**SOIL SITE EVALUATION
 for ON-SITE WASTEWATER SYSTEM**

Jerry Hamilton Bu's
 Johnson Farm's Sub.
 Lot 2 Saddle Lane

Show profile locations and other site features (dimensions, reference or benchmark, and North).

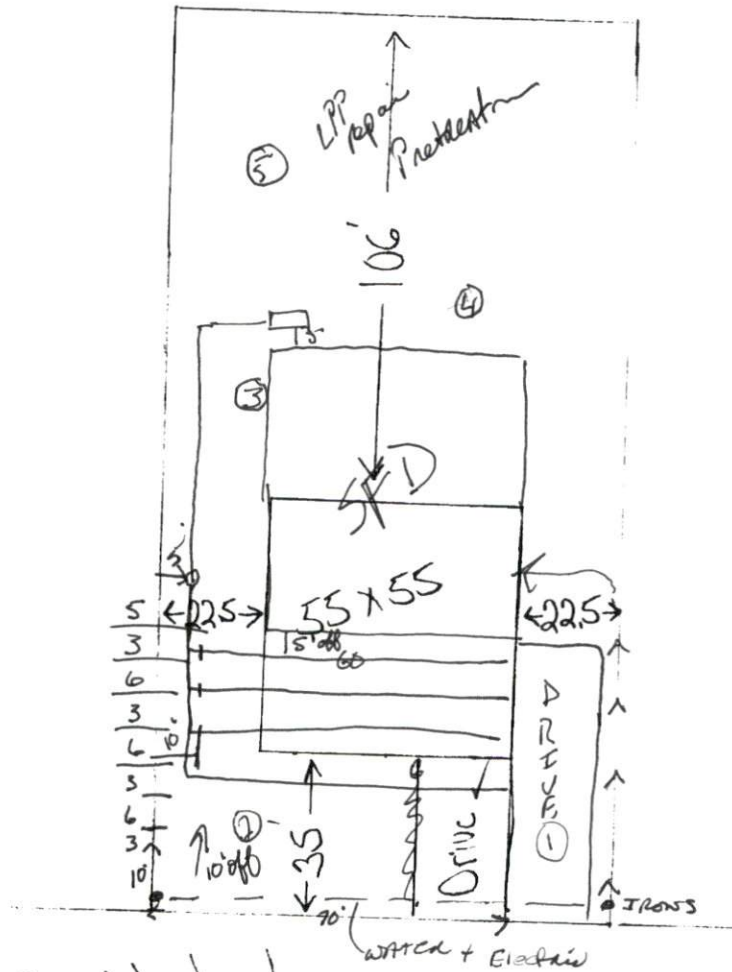
* NEED TO MOVE
 Home ~~over~~ even
 with forest
 Home

* PLATE needs
 changing
 to FAN
 RECEPT
 SIDE

* NEED'S
 50' CLEAR
 OF AREA
 70' OF CLEAR
